# TECHNICAL MEMORANDUM

**TO:** Craig Goodings  
**FROM:** Cameron Clayton  
Dan Walker  
Valerie Bertrand  
**EMAIL:** [drwalker@golder.com](mailto:drwalker@golder.com); [cclayton@golder.com](mailto:cclayton@golder.com); [vbertrand@golder.com](mailto:vbertrand@golder.com)  
**RE: MEADOWBANK GOLD PROJECT INTERNAL CONFORMITY TO  
PHC DECISION**

The Nunavut Impact Review Board (NIRB) recently completed an internal conformity review of the Final Environmental Impact Statement (FEIS) for the Meadowbank Gold Project to determine if Cumberland Resources has complied with NIRB's direction provided in the Preliminary Hearing Conference (PHC) Decision of July 14, 2005.

PROJECT		CUMBERLAND RESOURCES LTD.			
TITLE		GEOCHEMICAL SAMPLING LOCATIONS THIRD PORTAGE AND NORTH PORTAGE			
	PROJECT No. 04-1413-086		FILE No. 104-1413-086.dwg		
	DESIGN	PA	SEPT. 05	SCALE	AS SHOWN
	CADD	SHR	SEPT. 05		
	CHECK	PA	SEPT. 05		
REVIEW		DRAWING 1A

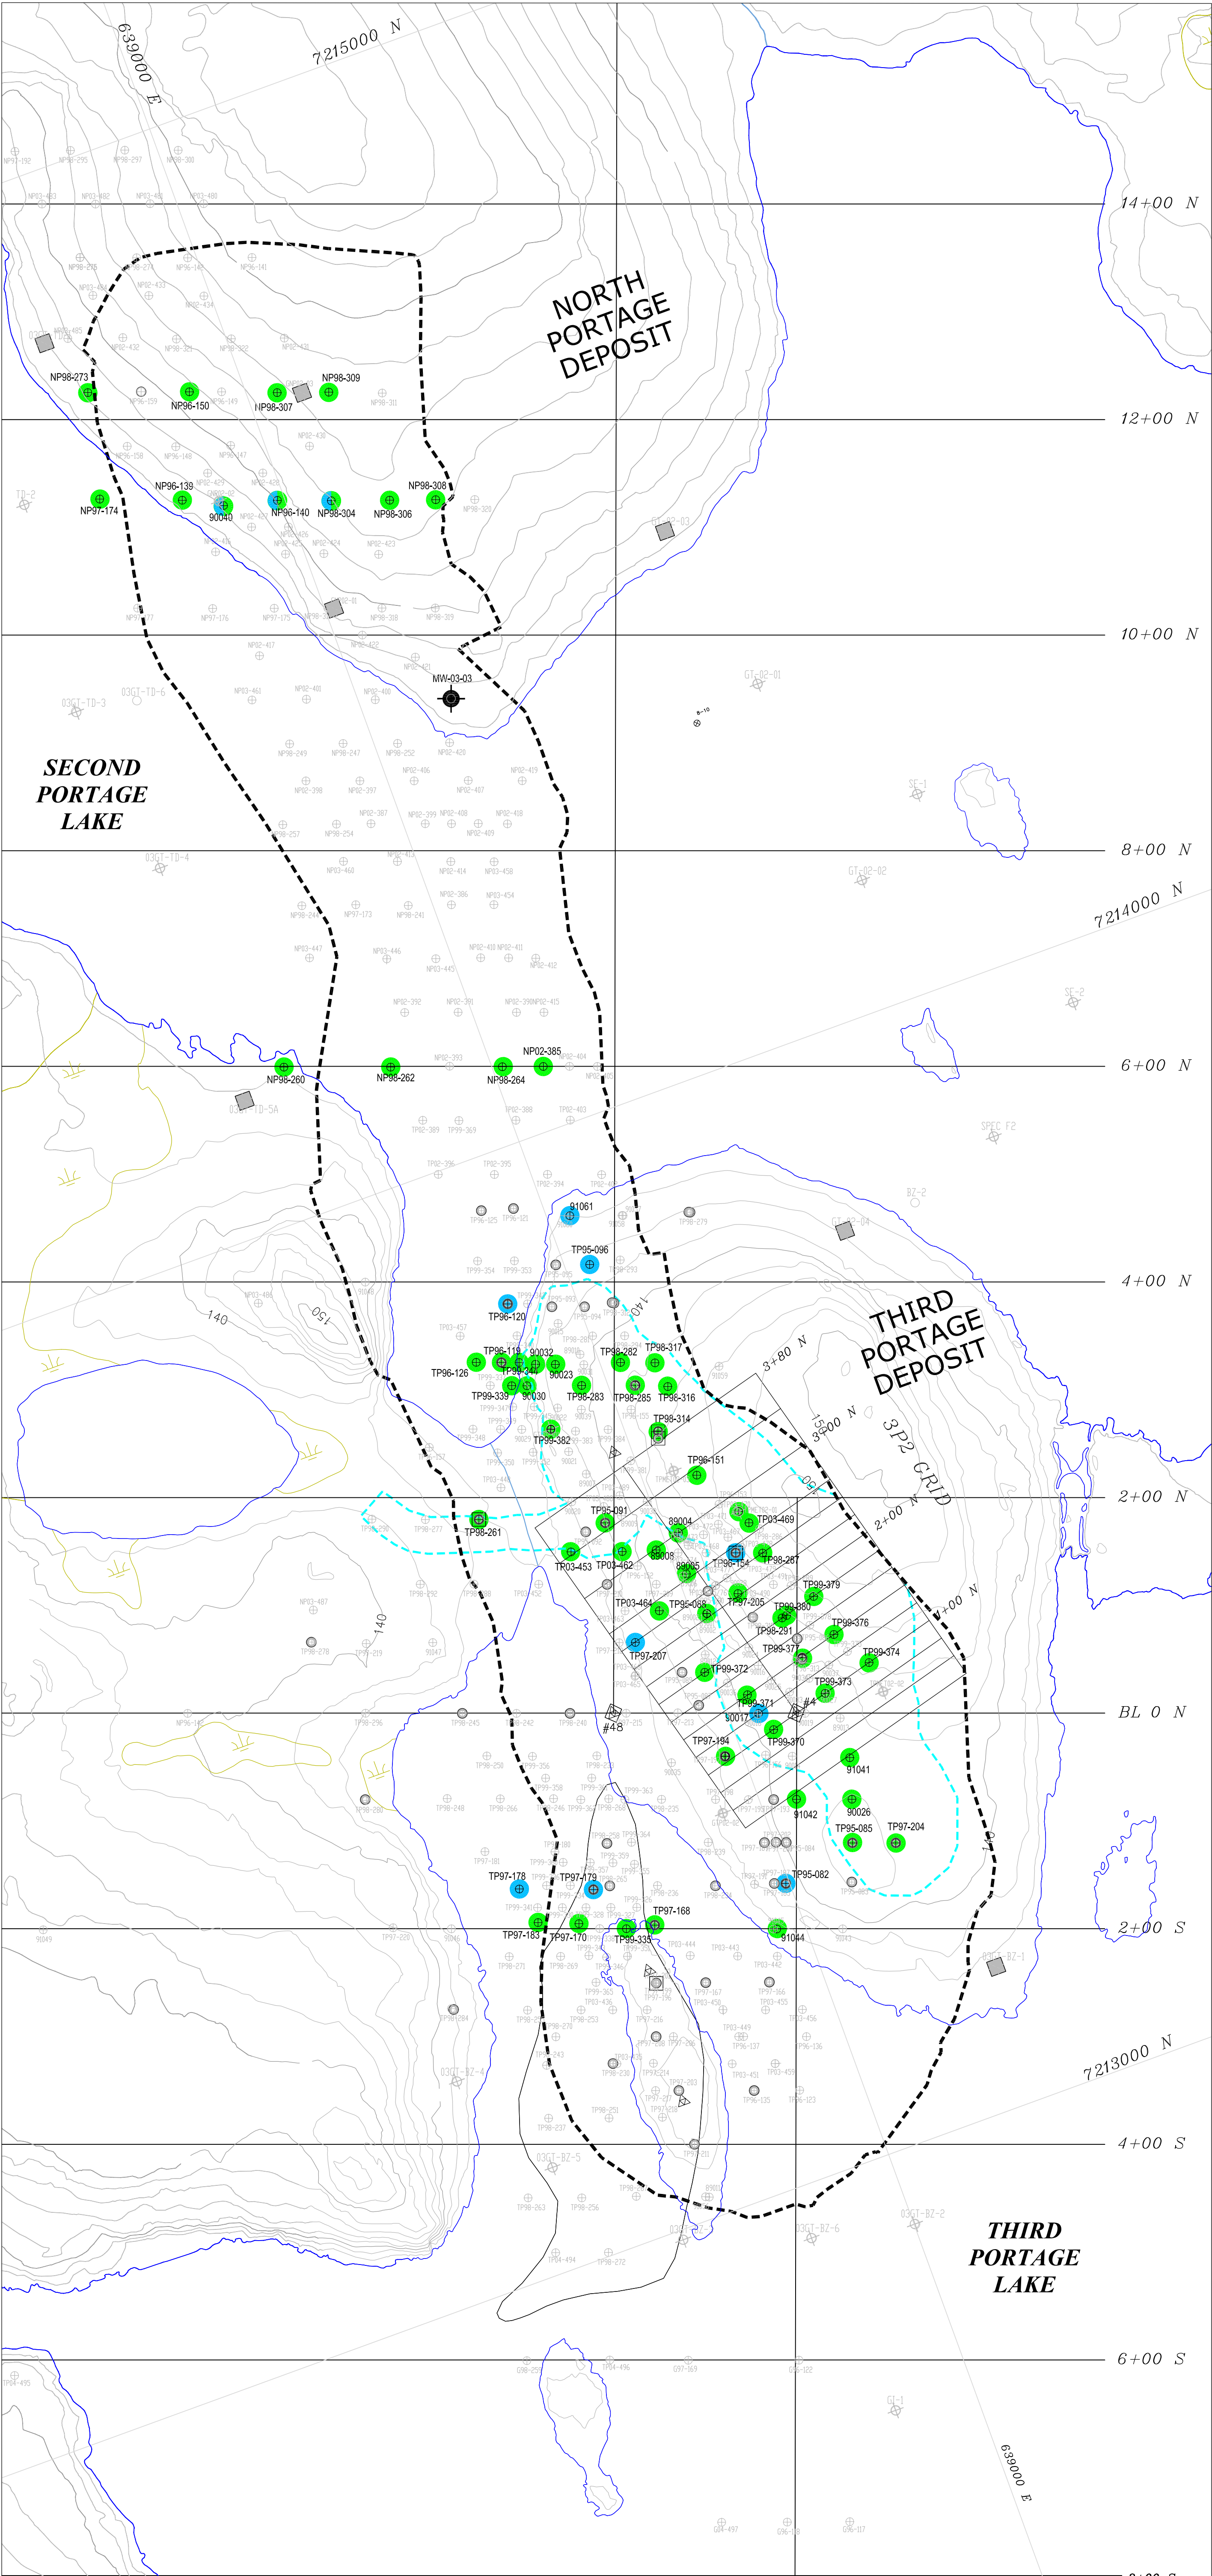
*“Drawings 1 and 2 are very difficult to impossible to read. Consider separating groups of samples onto separate drawings and ensure labels are legible.”*

Revised versions of Drawing 1 (made into two drawings: 1a and 1b) and Drawing 2 are provided as attachments.
